Access Compliance Report Public Rights-of-Way (Curb Ramps)

Main Street: GRASSY_KNOLL_LN Cross Street: SUNNYDALE_LN Location: SE

ADA ID: RPRK211019133255 Ramp Type: Type 4 - Parallel Initial Pass/Fail: Fail Overall Compliance: No Severity Score: 30

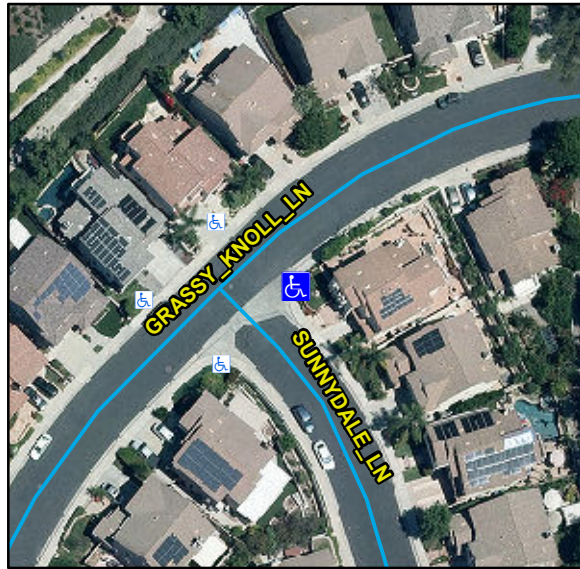
Compliance	Description	Data	Compliance	Description	Data
N/A	Ramp Length LT (in)	120	N/A	Ramp Length RT (in)	114
Yes	Ramp Width LT (in)	53	Yes	Ramp Width RT (in)	53
Yes	Ramp Run Slope LT (%)	8.2	Yes	Ramp Run Slope RT (%)	2.3
No	Ramp Cross Slope LT (%)	7.9	No	Ramp Cross Slope RT (%)	8
N/A	Landing Present	N/A	N/A	DWS Provided	N/A
N/A	Landing Length (in)	N/A	N/A	DWS Contrast	N/A
N/A	Landing Width (in)	N/A	N/A	DWS Length (in)	N/A
N/A	Landing Run Slope (%)	N/A	N/A	DWS Full Width	N/A
N/A	Landing Cross Slope (%)	N/A		DWS Offset Type	N/A
N/A	Landing Movement Obstructed?	N/A	N/A	DWS Offset Left (in)	N/A
	Landing Movement Type	N/A	N/A	DWS Offset Right (in)	N/A
N/A	Landing Shared	N/A			
N/A	Clear Space	Yes			
N/A	Clear Space To Crosswalk (in)	N/A			
N/A	Marked Crosswalk 1	No	N/A	Marked Crosswalk 2	No
	Crossing 1 Direction	NW		Crossing 2 Direction	SW
N/A	Marked Crosswalk 1 Width (in)	N/A		Marked Crosswalk 2 Width (in)	N/A

N/A	Ramp Inside Crosswalk 1	N/A	N/A	Ramp Inside Crosswalk 2	N/A
	Crossing 1 Slope (%)	3		Crossing 2 Slope (%)	1.4
	Crossing 1 Cross Slope (%)	7.8		Crossing 2 Cross Slope (%)	1.8
N/A	Gutter Ponding	N/A	N/A	Curb Slope	8.9
No	Gutter Lip Height (in)	0.25		Road Run Slope (%)	2.4
N/A	Gutter Run Slope (%)	N/A		Road Cross Slope (%)	4.4
N/A	Gutter Cross Slope (%)	N/A	No	Perpendicular Joint Present	No
Yes	Overall Surface Condition	Acceptable			
	Cross Gutter Present?	Yes		Spandrel Present?	Yes
	Replace Cross Gutter?	No		Replace Spandrel?	No

Remove & Replace Curb Ramp With Two New Directional Ramps or Equivalent. Grind Gutter Lip.

R204.3, R304.5.3, R302.7.2, STD 1115
